**Re: IDPR Project No. 310112
Priest Lake State Park – White Pine Campground Electrical Upgrades
Idaho Department of Parks & Recreation
Coolin, Idaho**

NOTICE OF CHANGES:

This **Addendum No. One** is hereby made a part of the project requirements and contract documents for the referenced project. Be sure to acknowledge this addendum on your Bid/Proposal Form. Failure to do so may subject the bidder to disqualification.

RECTANGULAR VALVE BOX

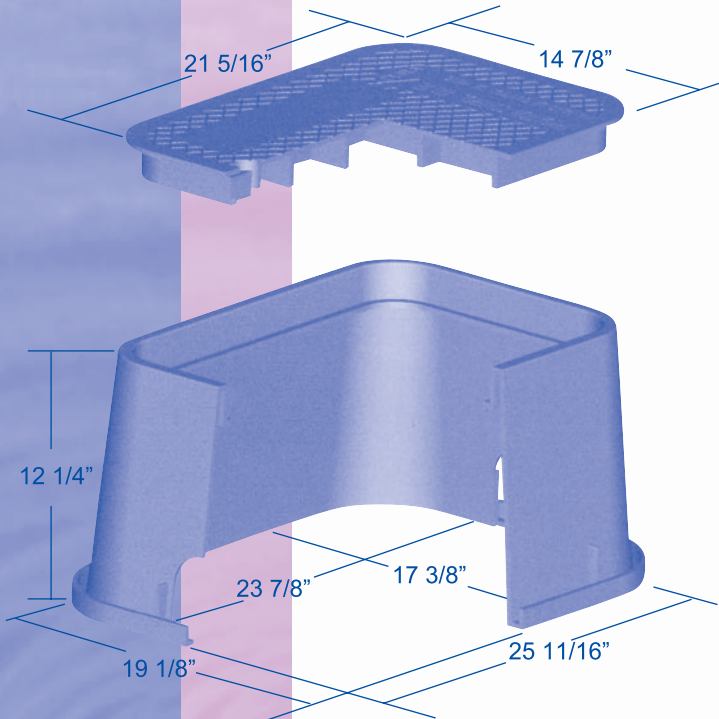
Is the attached valve box from Dura an acceptable substitute to the Carson valve box?

If the Carson valve boxes are not readily available, the Dura box is an acceptable substitute.
